# Access Compliance Report Public Rights-of-Way (Curb Ramps)

Main Street: WELLINGTON\_AVE Cross Street: HOWLAND\_WAY Location: NW

ADA ID: RPRK220121143114 Ramp Type: Type 4 - Parallel Initial Pass/Fail: Fail Overall Compliance: No Severity Score: 2

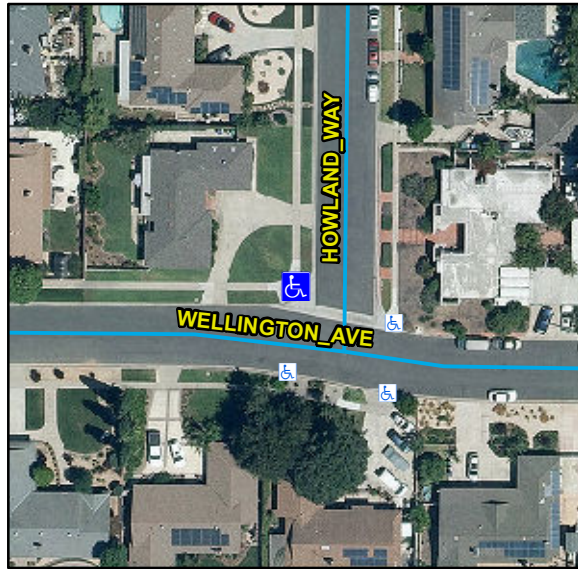
**R304.5.3, STD 1115**

| Compliance | Description                   | Data       | Compliance | Description                   | Data |
|------------|-------------------------------|------------|------------|-------------------------------|------|
| No         | Ramp Cross Slope LT (%)       | 2.4        | No         | Ramp Cross Slope RT (%)       | 3.3  |

**Remove & Replace Curb Ramp With Two New Directional Ramps or Equivalent.**
